SOUTHERN GROVE 4

Master Planned Unit Development MPUD
Amendment #2

APPLICATION FOR MPUD
OF SOUTHERN GROVE
(Parcel SG-4)

LIST OF AMENDMENTS (Amendment #2)

EXHIBIT 8 (proposed)

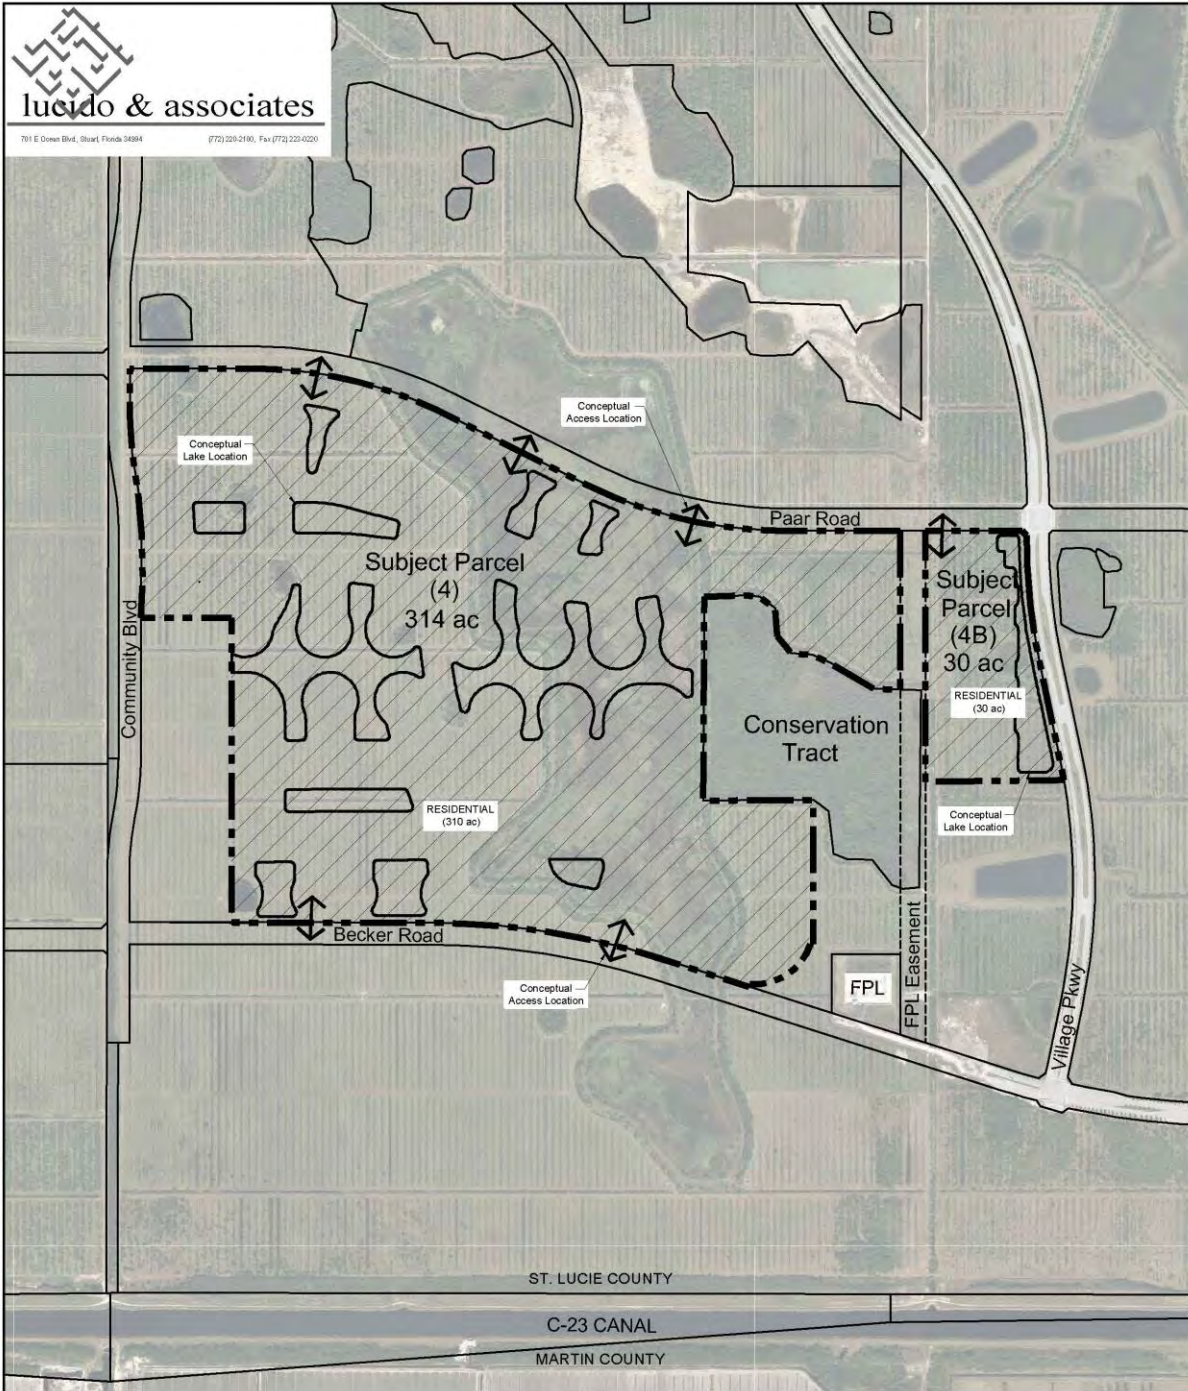
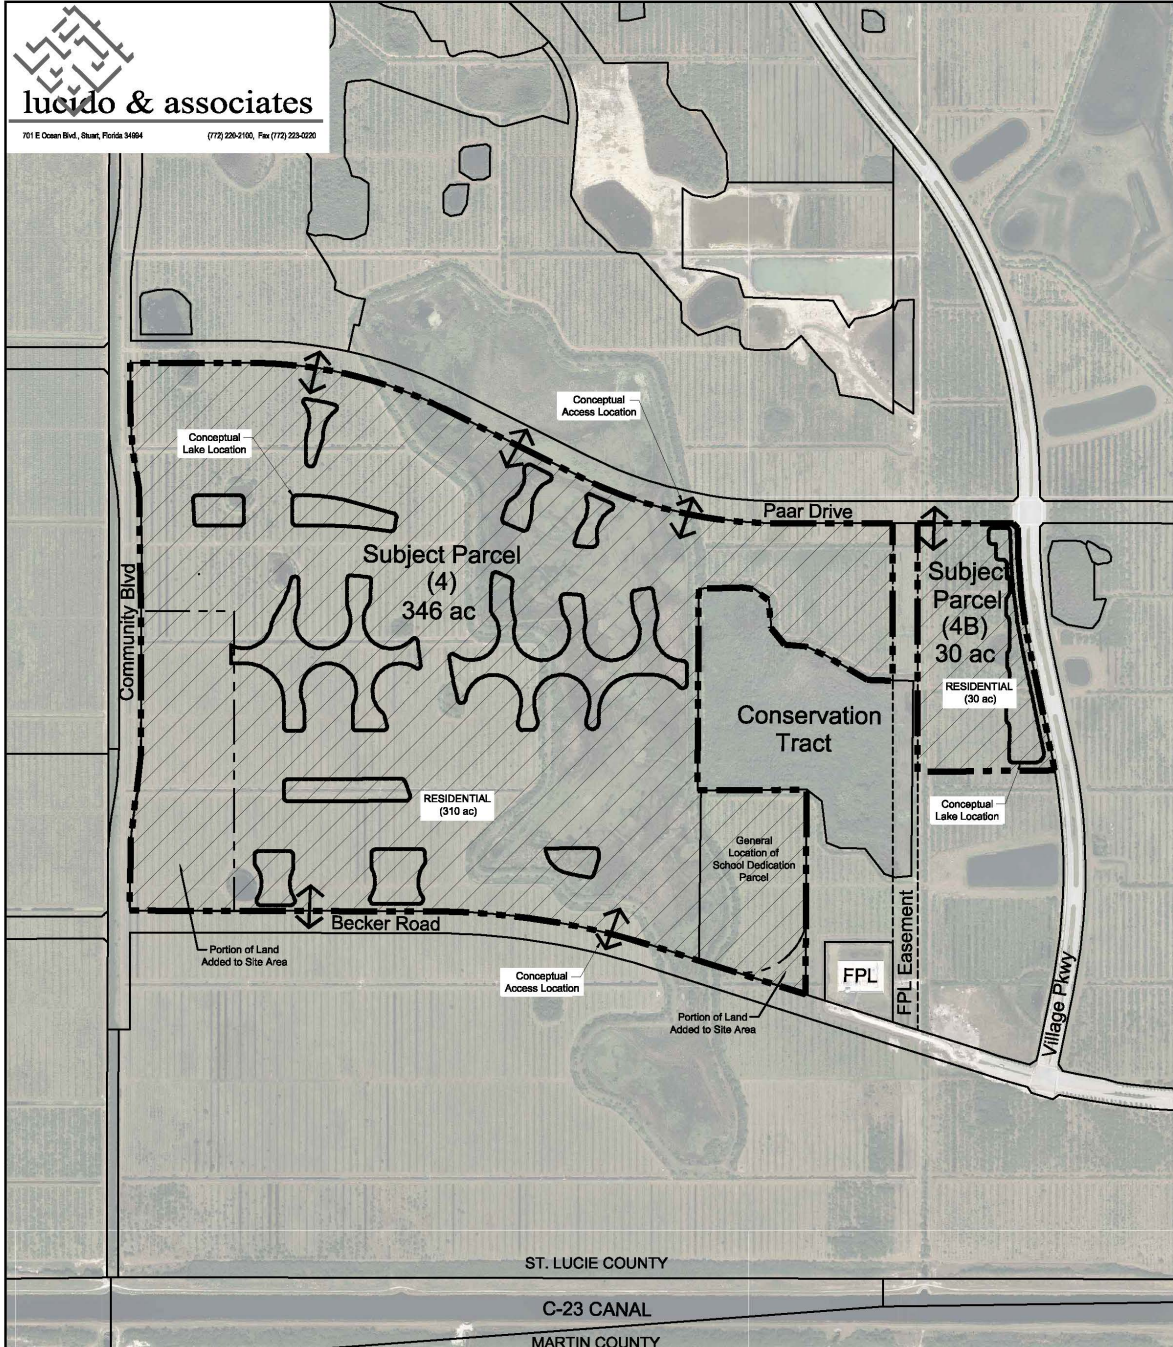
- Adjust MPUD parcel boundaries to add approximately 31.78 ac of land to the development area and adjust all maps and exhibits accordingly
- Include documentation to reflect ownership entities of Mattamy Palm Beach, LLC and CCC-PSL, LLC
- Provide sketch and legal descriptions for additional land area
- Refine terminology to include 'multi-family horizontal' and 'multi-family vertically attached' development programs
- Refinement of miscellaneous development criteria language as directed by the City
- Revise/add language regarding perimeter landscape buffer strips and wall requirements
- Revise conceptual land use plan to eliminate access arrows along Community Blvd
